Central London Cycle Grid within the City of Westminster

Camden Town to Little Venice Quietway

Stage 2 Road Safety Audit

Ref: 2602.02/001/UNC/BOR/2016

Location: A – Lyons Place junction with Aberdeen Place.

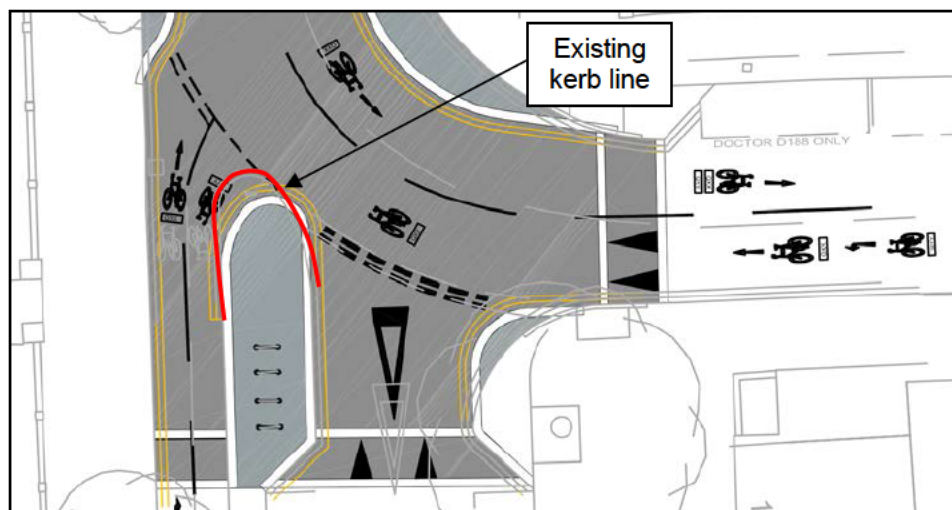
Summary: Tight turn and position of service cover for cyclists turning left from Lyons Place into Aberdeen Place cycle lane may result in cyclists losing control and falling from their bicycle.

The proposed route requires cyclists to turn left from Lyons Place onto Aberdeen Place. The angle of the turn is acute at approximately 50 degrees. In addition there is an existing metal service cover in the turning area. The acute turn and service cover could reduce grip and result in cyclists losing control and falling from their bicycle, especially in wet weather conditions.

Adjust the alignment of the physical island to provide a less acute turn angle and / or provide an infill cover to reduce the risk of a turning cyclist losing control of their bicycle.

In response to the Road Safety Auditor's recommendation, it is proposed to adjust the alignment of the island to provide a less acute turn angle for cyclists.

There are 2 Quietway routes which join at this junction. The design of Aberdeen Place/Lyons Place junction, shown on the drawings issued for RSA, is subject to change as a higher level of intervention is proposed that is being progressed as part of another Quietway route, namely; St John's Wood to Marylebone Quietway.

The proposed design for this junction is shown below and includes a redesign of the existing island which will provide a more comfortable manoeuvre for cyclists turning left from Lyons Place into Aberdeen Place. The proposed design also increases the size of the mouth of the access into the existing bi-directional cycle track which decreases the likelihood of cyclists coming into contact with the service cover.

Location: General to Scheme – Blomfield Road speed humps.

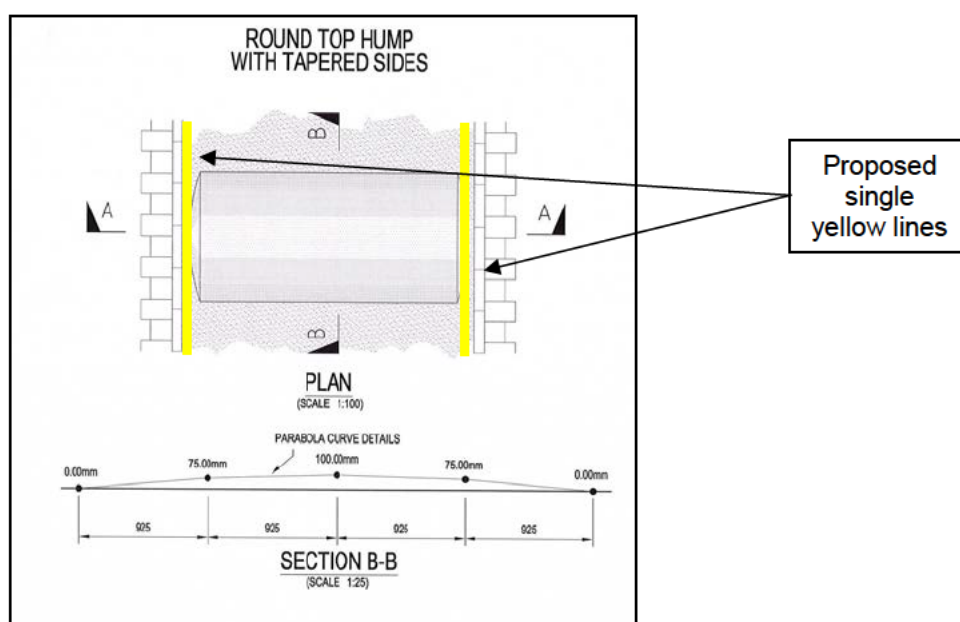
It is proposed to replace the existing speed cushions with sinusoidal humps. No standard detail has been provided for the proposed sinusoidal hump, however it is assumed that the road humps will have tapered ends which terminate close to the kerb to allow water to drain around them (no additional drainage provision on Blomfield Road is detailed on the drawings). If this is the case, the yellow line markings proposed along the kerb should be deflected over the hump to guide vehicles away from the taper. It may be beneficial to realign the markings.

The existing single yellow lines along Blomfield Road follow the kerb edge and will be replaced as existing following the construction of the sinusoidal speed humps.

A typical standard detail of the type of sinusoidal speed hump which will be used is illustrated below. Please note that this is not an approved Westminster City Council standard detail but illustrates how the waiting restrictions would be installed at the kerbside.

Westminster standards to be followed for the parking and loading restrictions.

Location: 1 – Blomfield Road (opposite No. 9).

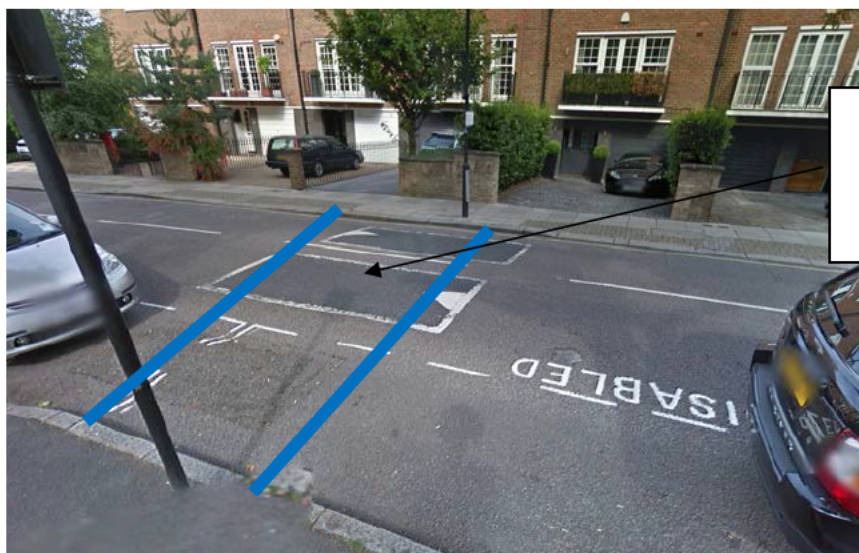
There is an existing disabled parking bay opposite number 9 Blomfield Road. The western side of the bay will be located on a proposed speed hump (it is acknowledged that the bay is currently located adjacent to the speed cushions, however these appear to have little impact on the bay itself). The hump could pose accessibility issues for mobility impaired drivers / passengers, especially those in wheelchairs. It is recommended that the hump is moved further east or west such that the disabled bay is located on a level surface.

The sinusoidal speed humps are to replace the speed cushions in their existing locations. The photograph below illustrates that it is difficult to locate the sinusoidal hump further to the north or south due to its proximity to off-street residential parking and dropped crossover which would pose build ability and functionality issues.
